Re: FortisBC Inc. (FBC)

**Application for a Certificate of Public Convenience and Necessity for Approval
of the Fruitvale Substation Project (Application)**

**Response to the Industrial Customers Group (ICG) Information Request (IR) No.
1**

Attachment 3.1

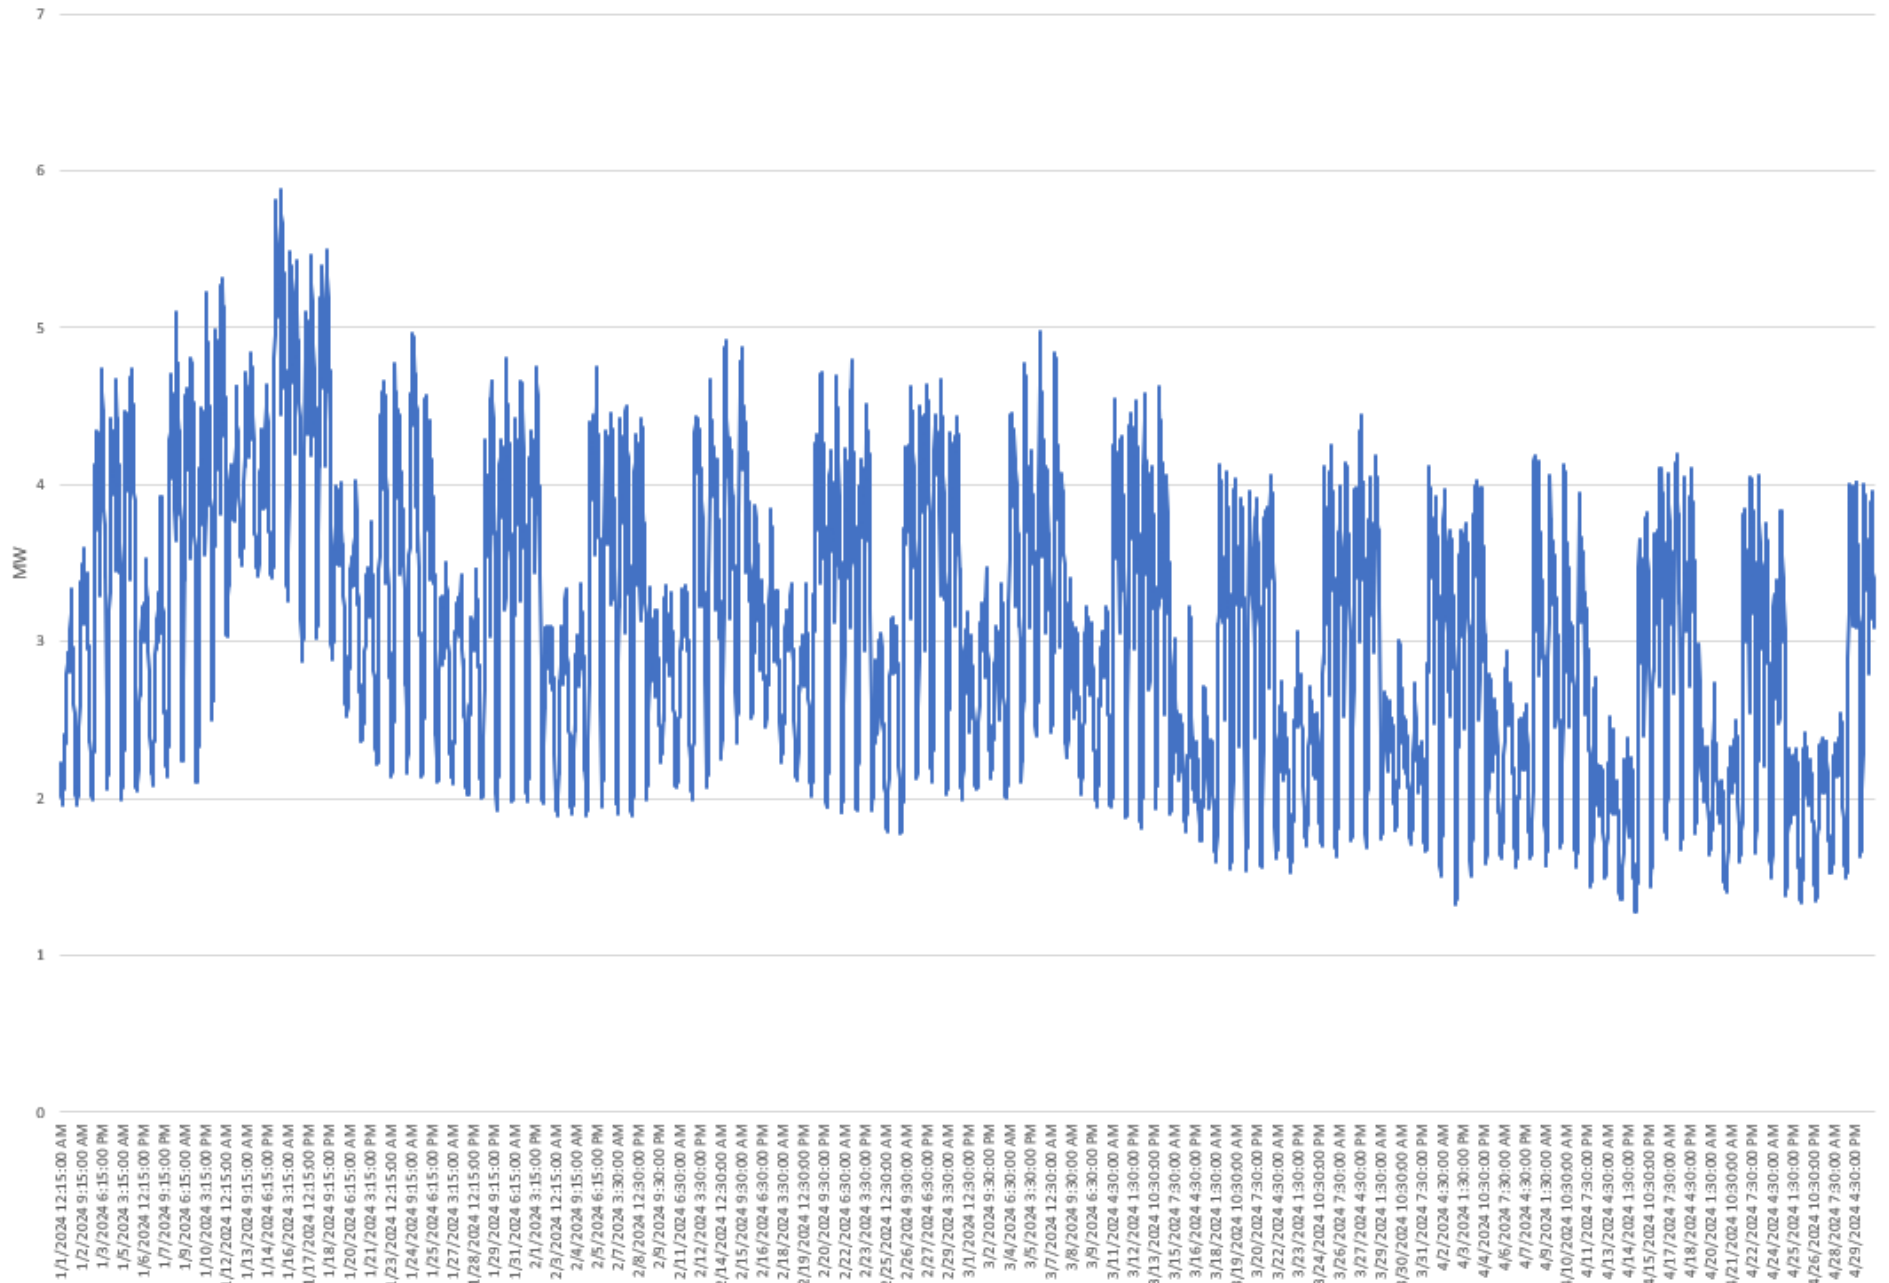
4 1.1 Further to BCUC IR 3.1, please provide a graph and table of the annual peak winter
5 and summer loads served by each of the FRU and HER substations over the last
6 10 years, and specify if any peaks at one station include loads transferred from the
7 other station.

10 FBC provides the requested information in the table below and in Attachment 1.1. FBC notes the
11 following with respect to the information provided:
